ALERT SERVICE BULLETIN
Bell Helicopter **TEXTRON**

NO. 427-07-16

SUBJECT: CARGO HOOK STRESS CORROSION CRACKS

Document No. 159-017-00 Rev 0

Figure 1. Crack location

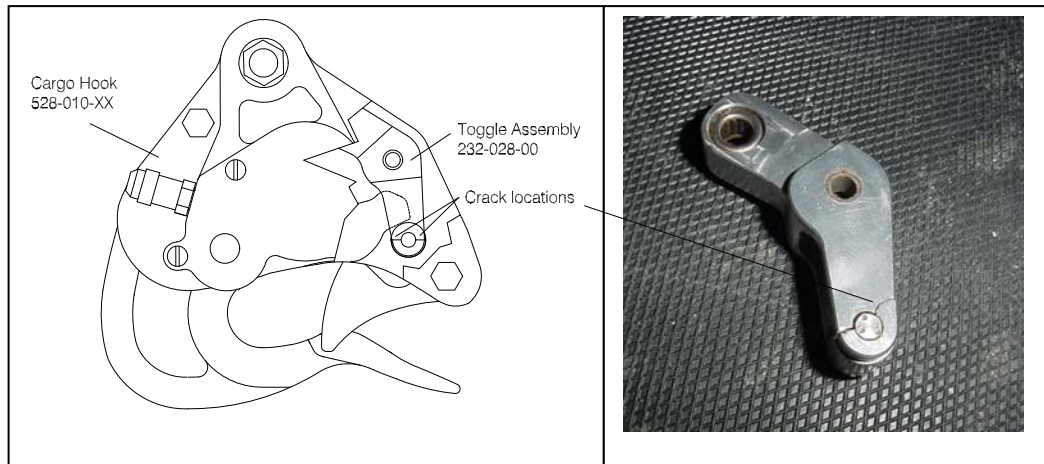
Description: Onboard Systems has had two reported instances of failure of the Toggle Assembly, 232-028-00. The Toggle is an internal component of Cargo Hook 528-010-XX and is a primary element of the Cargo Hook locking mechanism. Figure 1 shows the location of the failure.

Cause: Investigation of the failures has suggested that they were caused by Stress Corrosion Cracking (SCC). Specific mechanical, metallurgical, and corrosive conditions must be present in order for SCC to occur.

In the case of the Toggle Assembly, these conditions were satisfied by—

1. Residual stresses imposed by the press fit of the Load Beam Roller Pin
2. Corrosive salt water environment

Figure 2. Crack Locations in Toggle 232-028-00

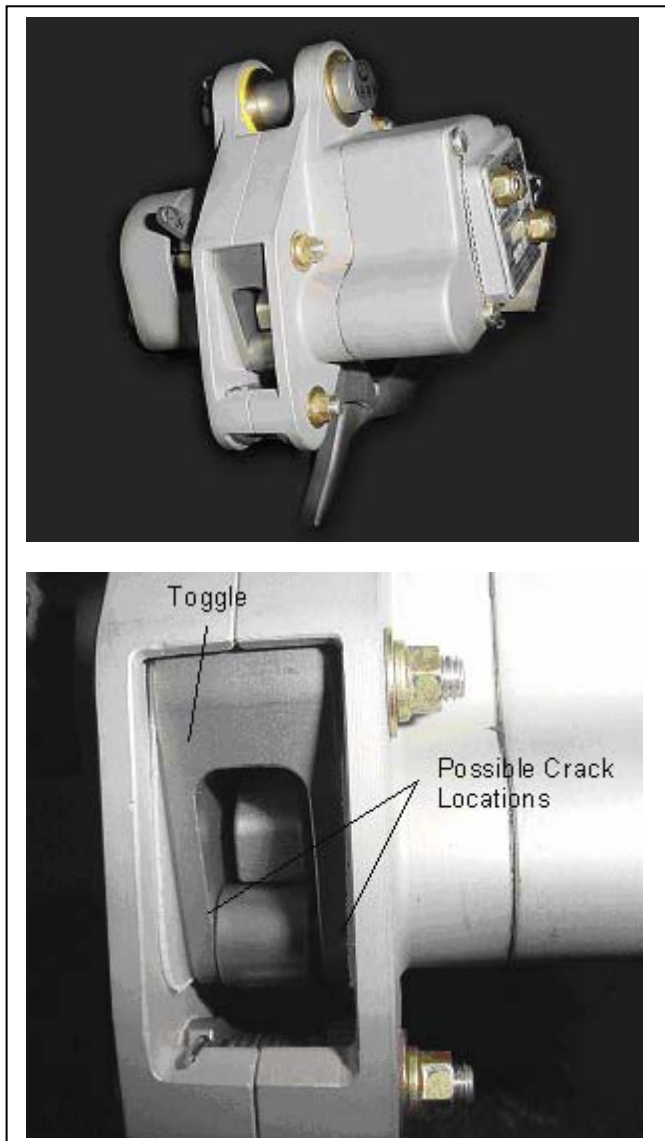
1. Visually check the Toggle for cracking or separation, as viewed in figure 2 in the assembled Cargo Hook.
2. Operate the Cargo Hook per the preflight instructions in the RFMS. If the Cargo Hook does not function properly, it must be removed from service and the part 2 instructions must be accomplished prior to use.

1. Remove Cargo Hook from aircraft. Refer to appropriate ICA or Owner's Manual instructions.
2. Disassemble Cargo Hook per Service Manual instructions. Remove Toggle 232-028-00 and replace with Toggle 232-028-01*.

Figure 4. Install New Thrust Plates.

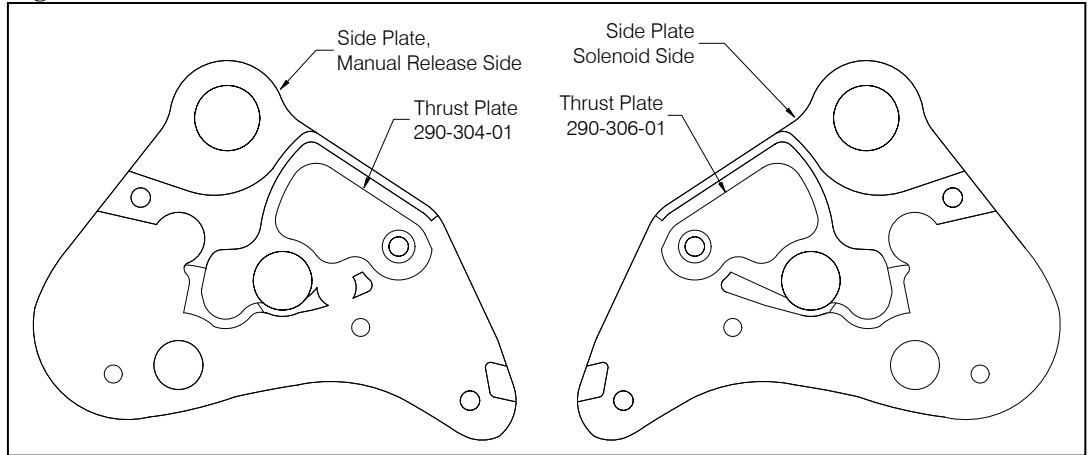
3. Remove Thrust Plates 290-306-00 from the inside of the cargo hook side plate on the solenoid side and 290-304-00 from the inside of the opposite side plate and replace with Thrust Plates 290-306-01 and 290-304-01 respectively as shown in Fig. 4**.

***The Thrust Plates must be replaced or the new Toggle will not function properly.*
